VA Hot Springs DOM Renovation Building 8  
Hot Springs, South Dakota

**ADDENDUM NO.:** 01**DATE ISSUED:** 08-22-2025**BIDS DUE:** 09-03-2025**ARCHITECT'S PROJECT NO:** 211921

**Date:** 8/22/2025**Project:** Dom Renovation for Semiprivate Rooms**To:** All Plan Holders**Project #:** VA# 568-20-208, WPE# BR21039**From:** David Dowling/Michael Heinrich, Mike Sigman**Project Location:** Hot Springs, South Dakota**Addendum Number:** #001

**B4 BUILDING SECTION - W/E**  
1/8" = 1'-0"

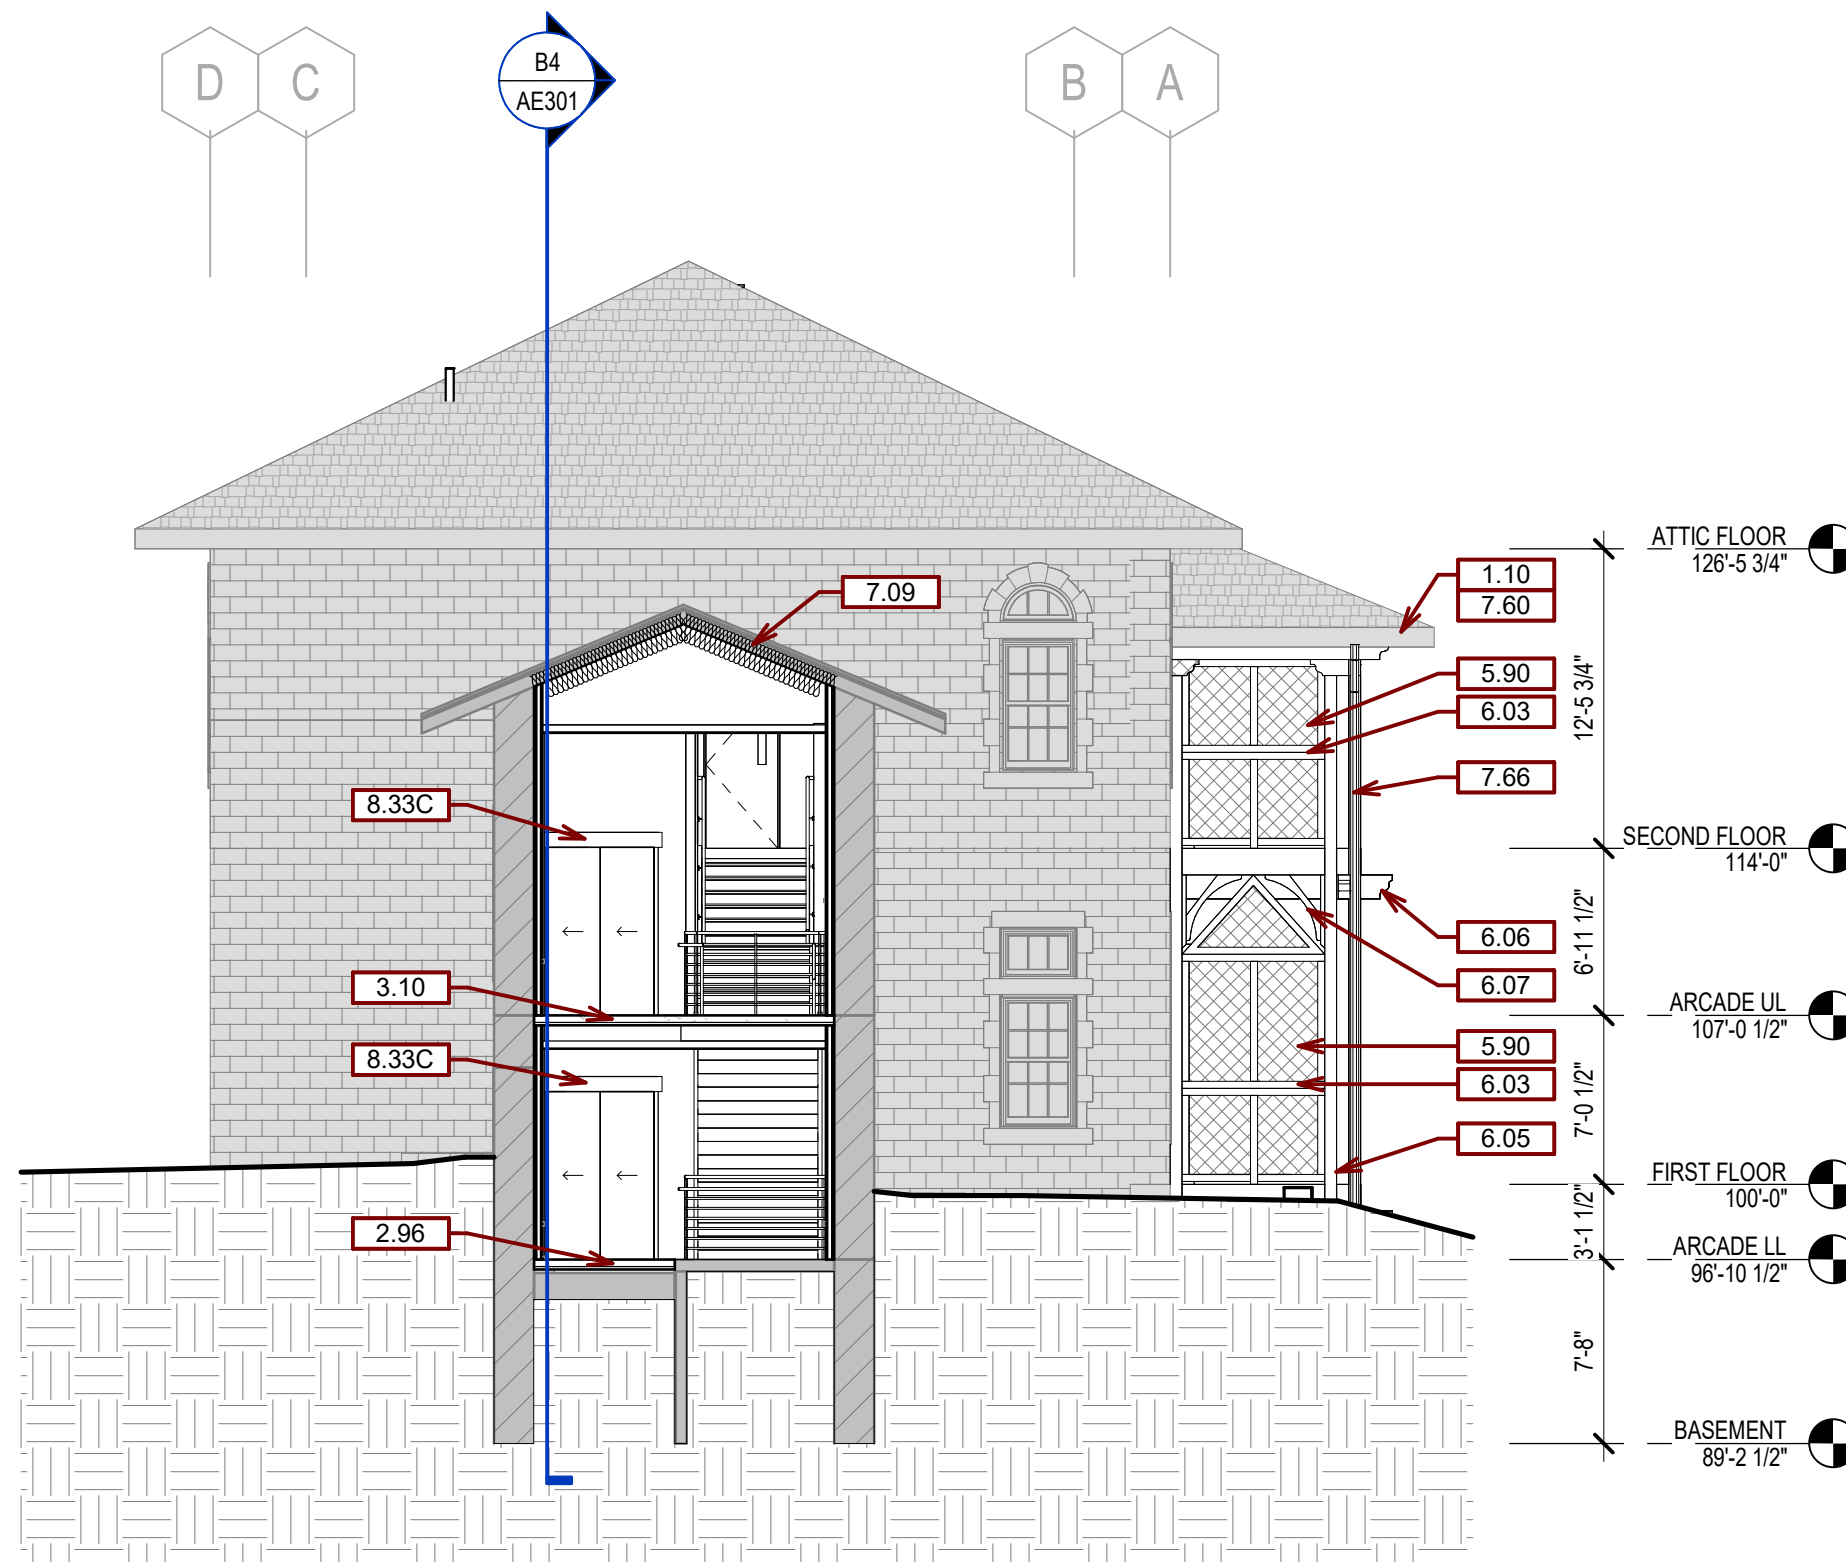
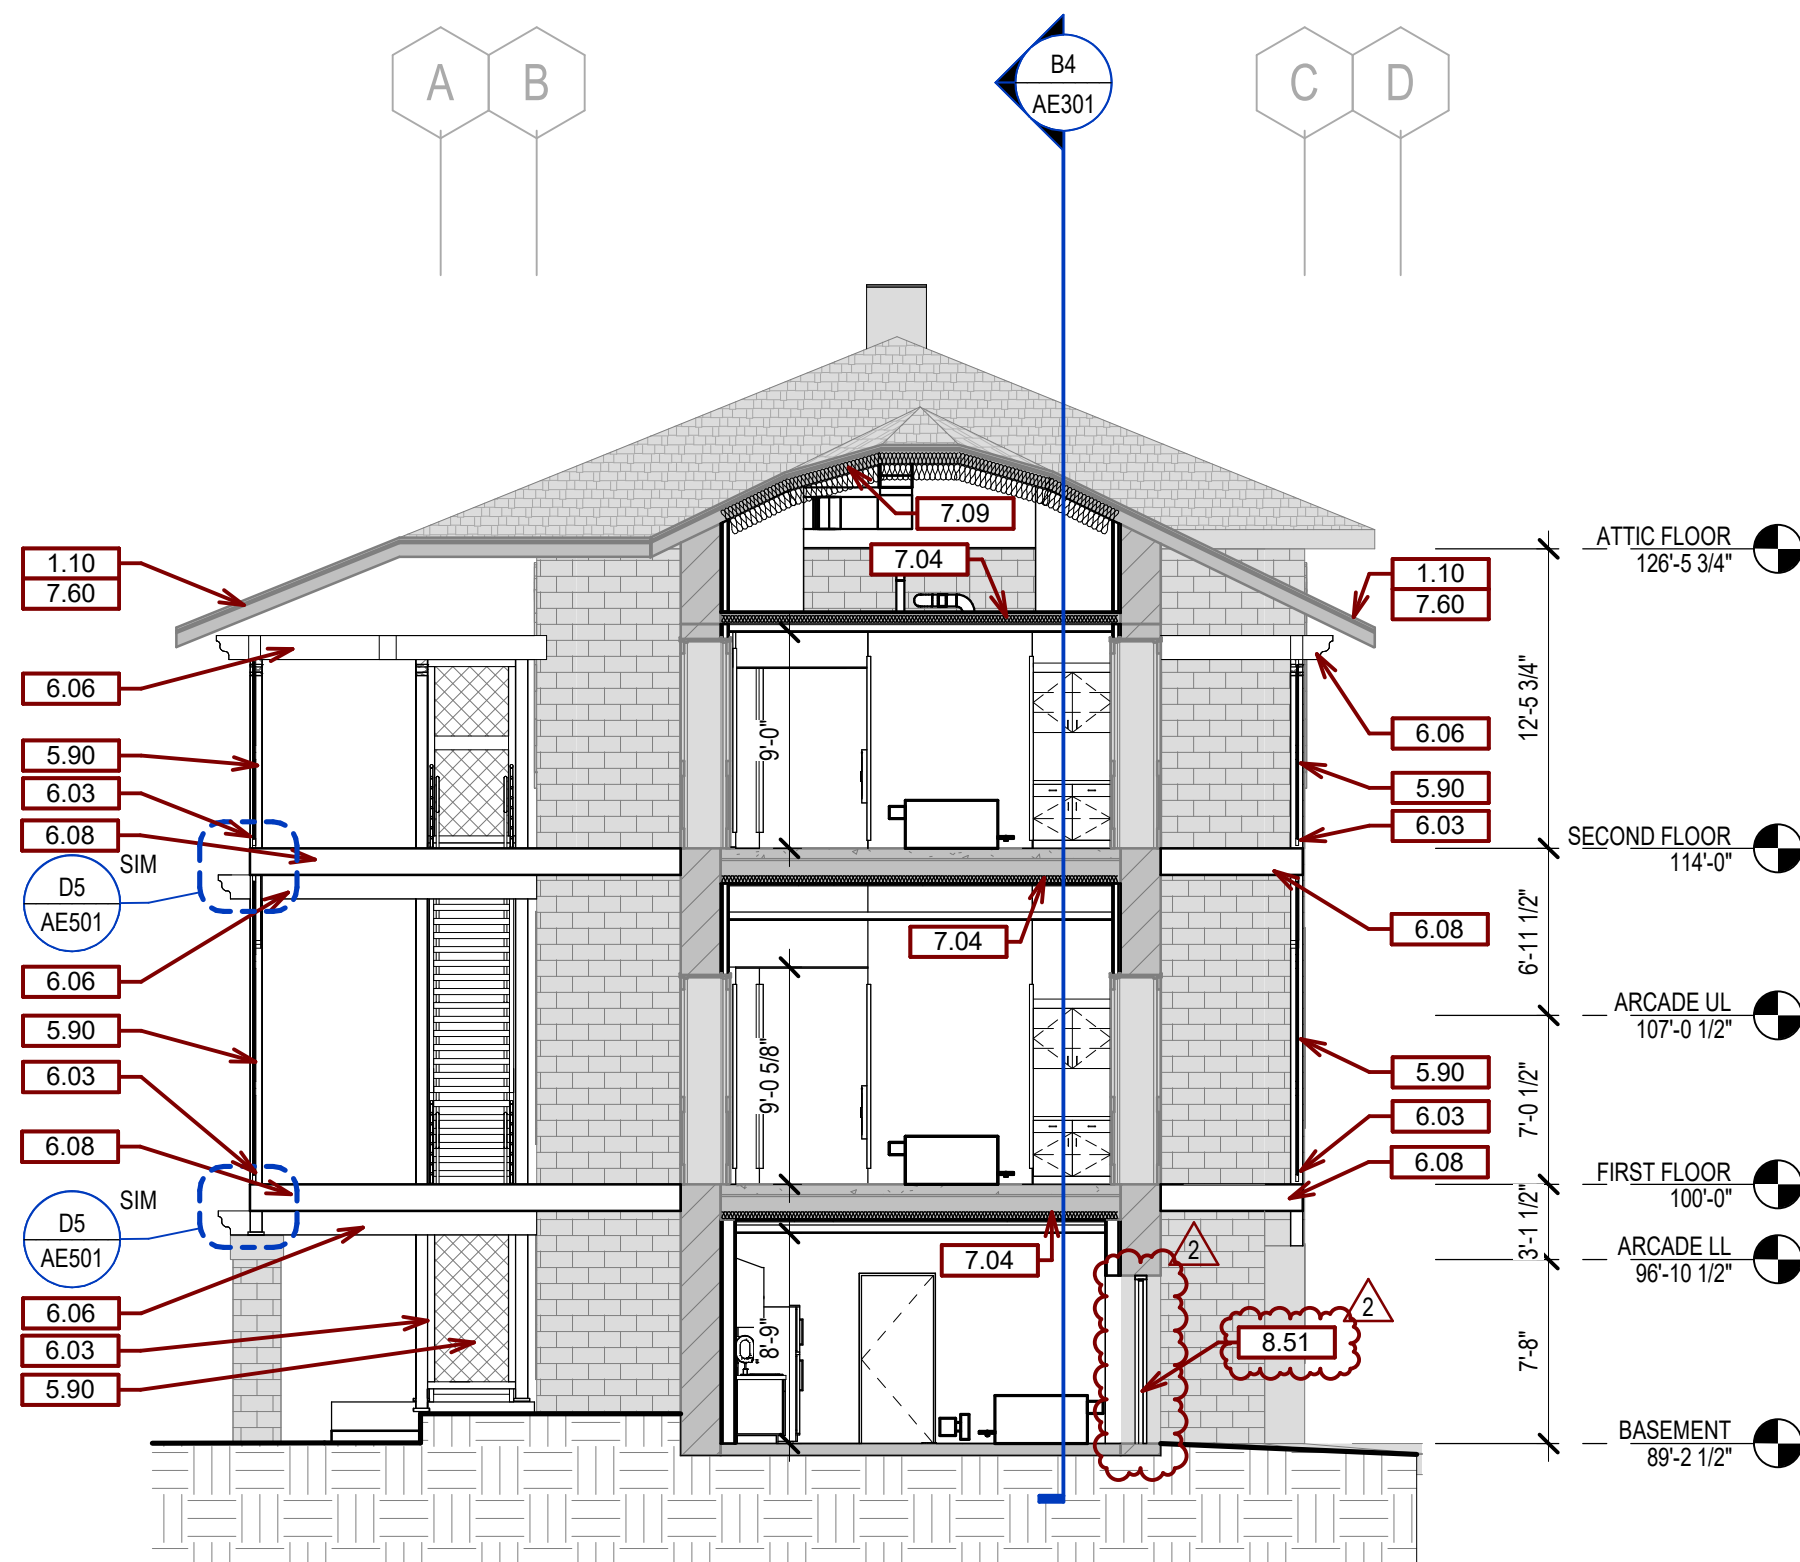
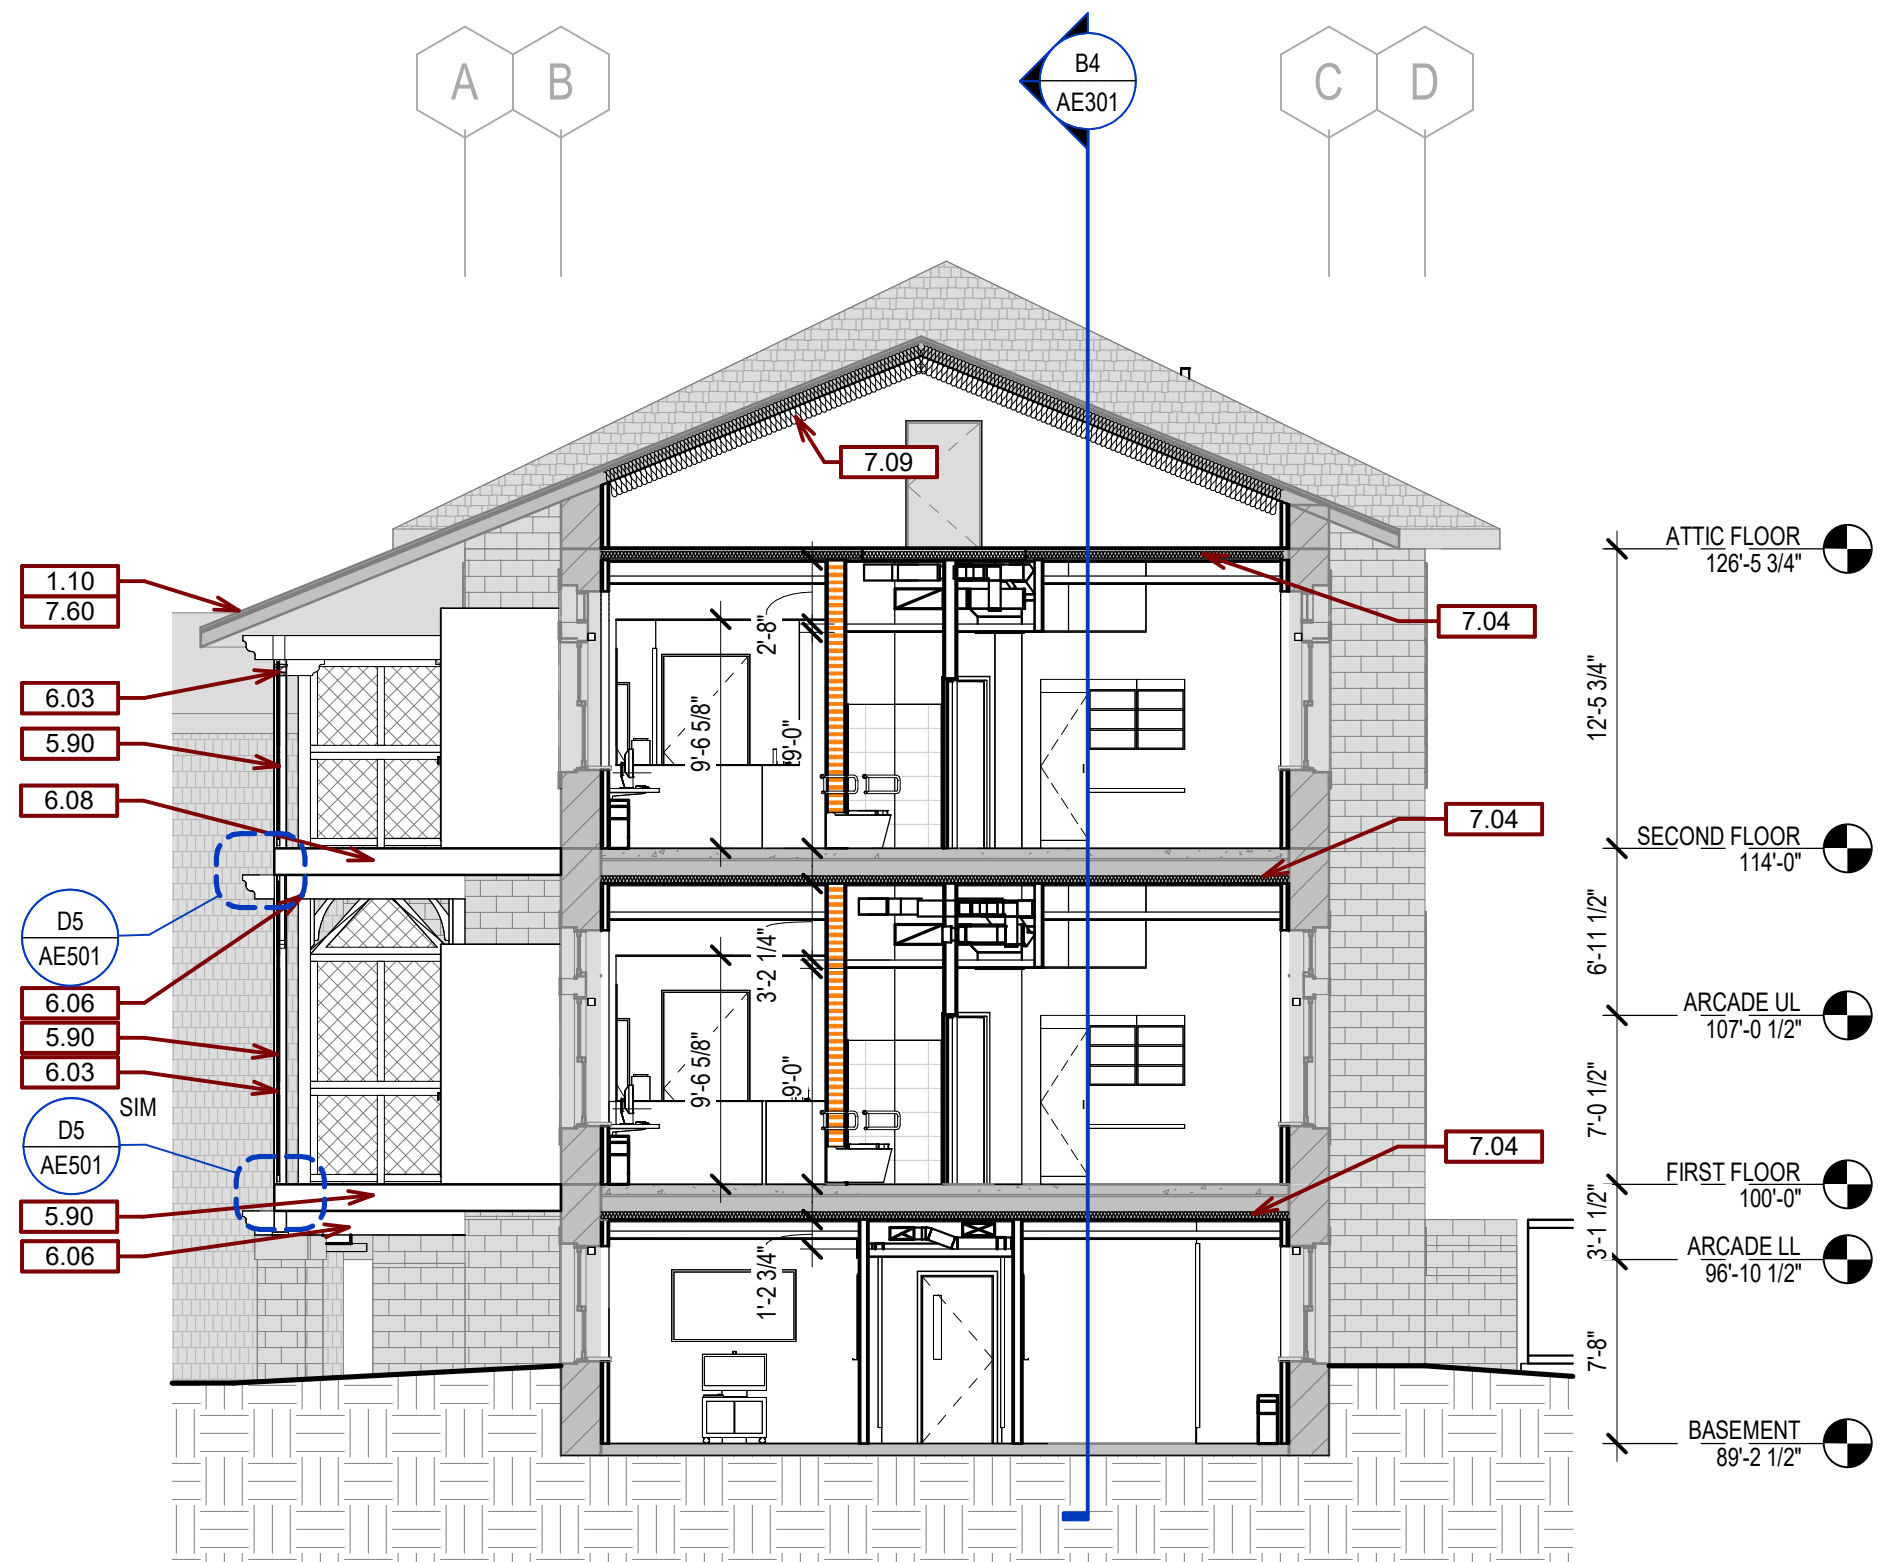
ITEM NO: 11: AE301 – Building Sections

- a) Updated background to show a new exterior door in the basement.
- b) Added keynote to new exterior door in basement (8.51).

### FINISH AND SIGNAGE PLAN - BASEMENT

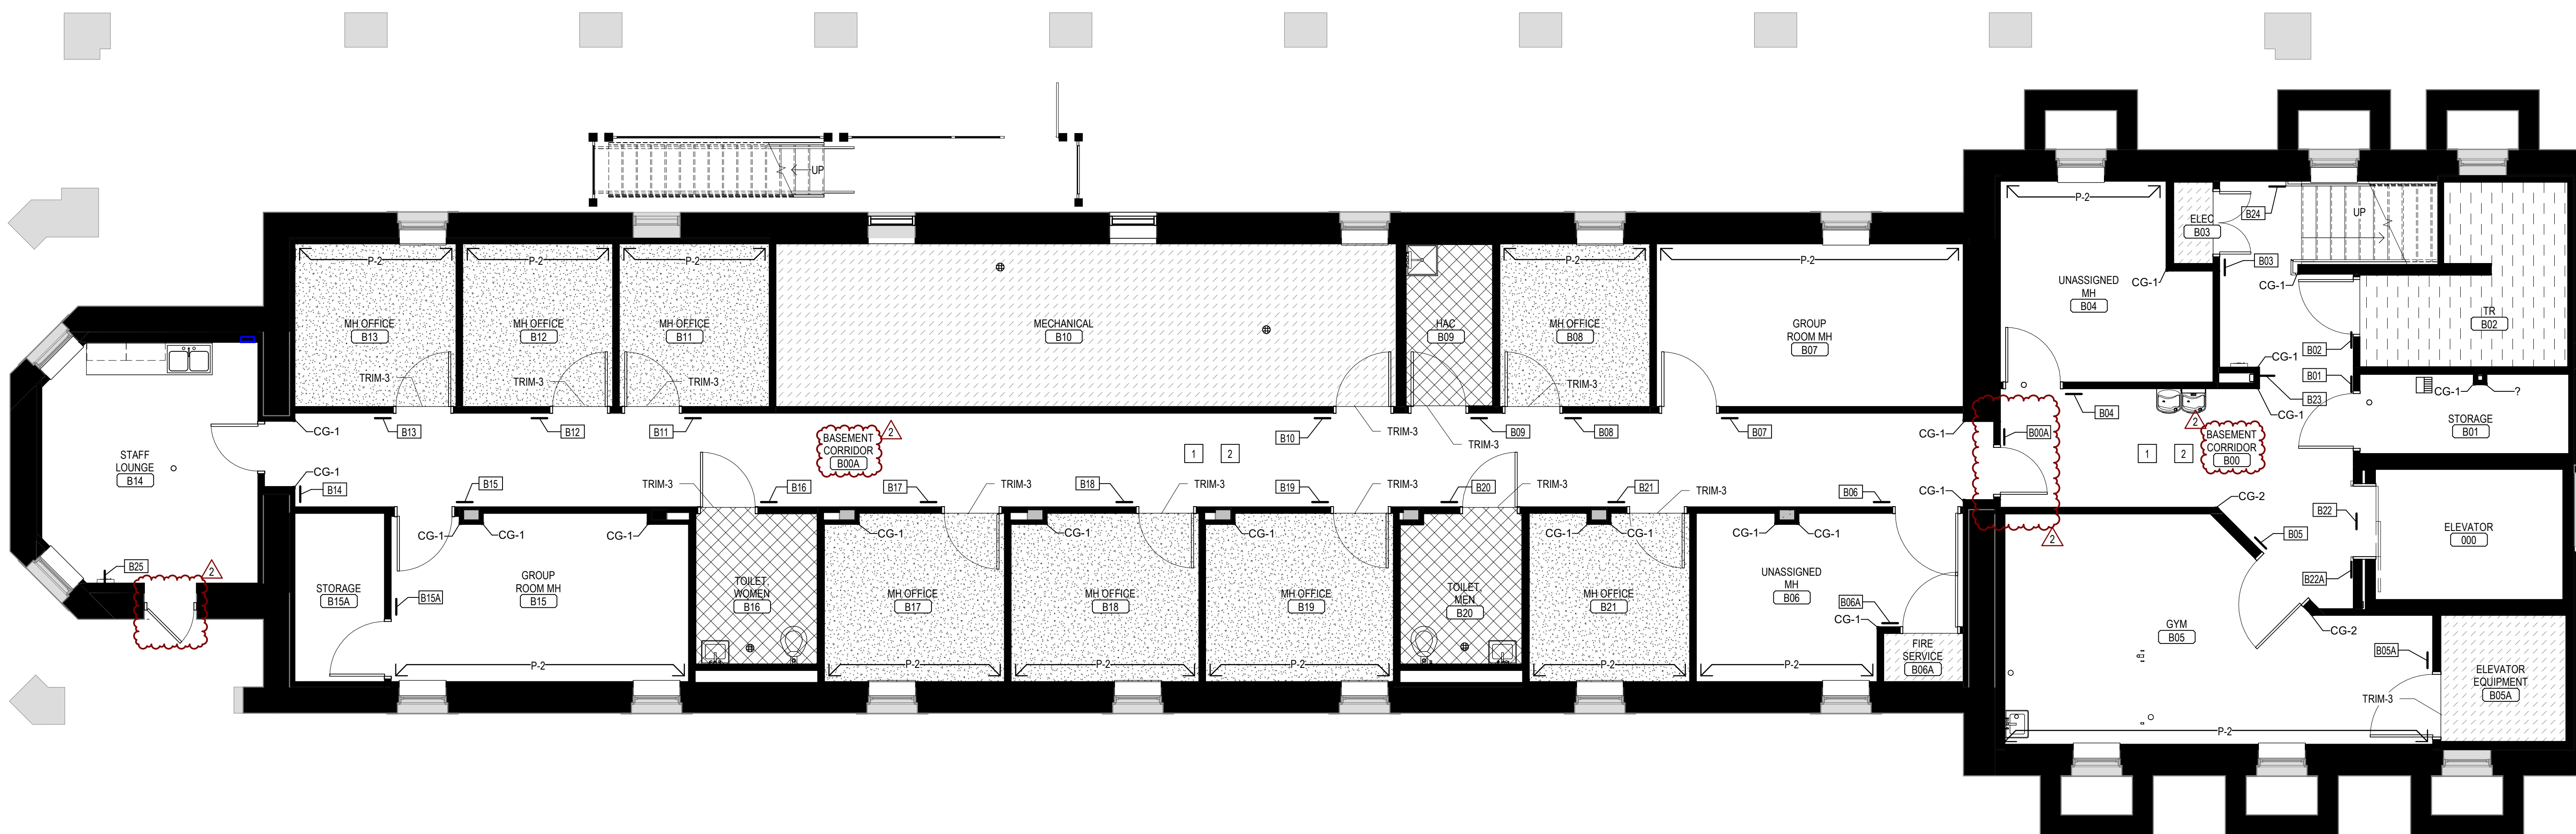
ITEM NO: 13: AI100 – Finish and Signage Plan – Basement

- a) Updated background to show a new exterior door in the basement.
- b) Updated background to show a new corridor door in the basement.

- c) Split basement corridor into two separate rooms and adjusted naming/numbering accordingly.
- d) Added room sign adjacent to new corridor door (B00A).
